Change Order: Additional Compliance Measures for Constructor Role and Unforeseen Conditions to the Envelope Repairs and Structural Rehabilitation Project at Mornelle Ellesmere

Report:	BIFAC:2021-13
То:	Building Investment, Finance and Audit Committee ("BIFAC")
From:	Vice President, Facilities Management
Date:	January 5, 2021

The purpose of this report is to seek the BIFAC's approval for the change order to Tritan Inc. ("Tritan") for constructor role services and unforeseen conditions to the recladding project at Mornelle Ellesmere (110 Mornelle Court).

<u>Image 1:</u> Example of the current conditions of the structural reinforcement at the balcony slabs. Once uncovered, it was revealed that portions of the steel reinforcement required replacement, as well as a coating to prevent continued deterioration and rusting.

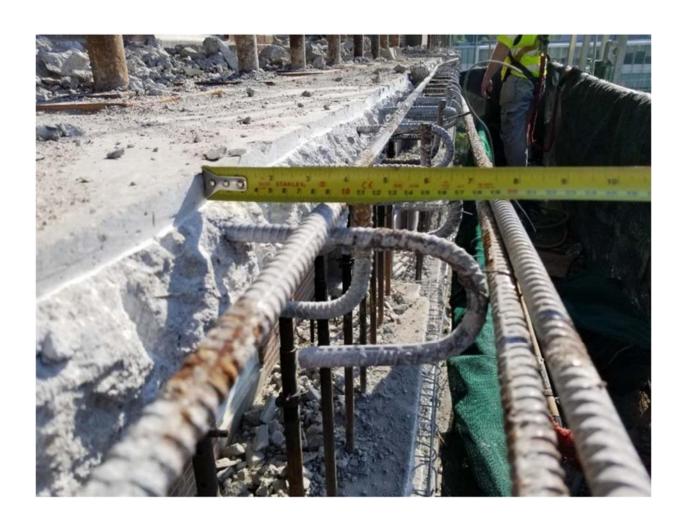
- An increase in pricing for the relocation of Rogers Telecommunication equipment; and
- Additional costs for work and materials for structural reinforcement at the balcony slabs and waterproofing around building windows.

Reason for change – Unforeseen site condition
